# Access Compliance Report

## Public Rights-of-Way

Intersection ID: 3053	Main Street: WHITE_STAG_DR	Cross Street: WHITETAIL_CT	Location: NW
ADA ID: AB25AAC2C715	Ramp Type: Perp	Initial Pass/Fail: Fail	Overall Compliance: No
Severity Score: 8.75			
Codes/Mitigation Info/Possible Solution		Field Measurements/Component Compliance

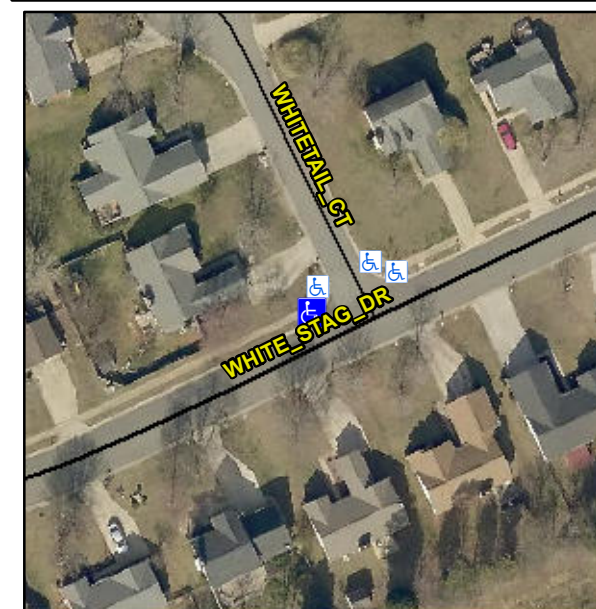
**R304.5.1**

Compliance	Description	Data	Compliance	Description	Data
N/A	Ramp Length (in)	48.0	Yes	Ramp Slope (%)	8.1
No	Ramp Width (in)	36.0	Yes	Ramp XSlope (%)	2.0
N/A	Flare Type LT	N/A	N/A	Flare Type RT	N/A
N/A	Flare Slope LT (%)	N/A	N/A	Flare Slope RT (%)	N/A
N/A	Flare Traversable LT?	N/A	N/A	Flare Traversable RT?	N/A
N/A	Landing Length (in)	N/A	N/A	DWS Provided?	N/A
N/A	Landing Width (in)	N/A	N/A	DWS Contrast?	N/A
N/A	Landing Slope (%)	N/A	N/A	DWS Length (in)	N/A
N/A	Landing X Slope (%)	N/A	N/A	DWS Full Width?	N/A
N/A	Landing Curb? (Y/N)	N/A	N/A	DWS Offset (in)	N/A
N/A	Shared Landing?	N/A			
N/A	Gutter Ponding?	N/A	N/A	Gutter Slope (%)	N/A
N/A	Gutter Lip Ht (in)	N/A	N/A	Gutter X Slope (%)	N/A
N/A	Painted X Walk1?	No	N/A	Painted X Walk2?	N/A
	X Walk 1 Direction	To S		X Walk 2 Direction	N/A
N/A	X Walk 1 Width (in)	N/A	N/A	X Walk 2 Width (in)	N/A
	X Walk 1 Slope (%)	6.6		X Walk 2 Slope (%)	N/A
	X Walk 1 X Slope (%)	1.1		X Walk 2 X Slope (%)	N/A

**Remove & Replace Entire Ramp.**
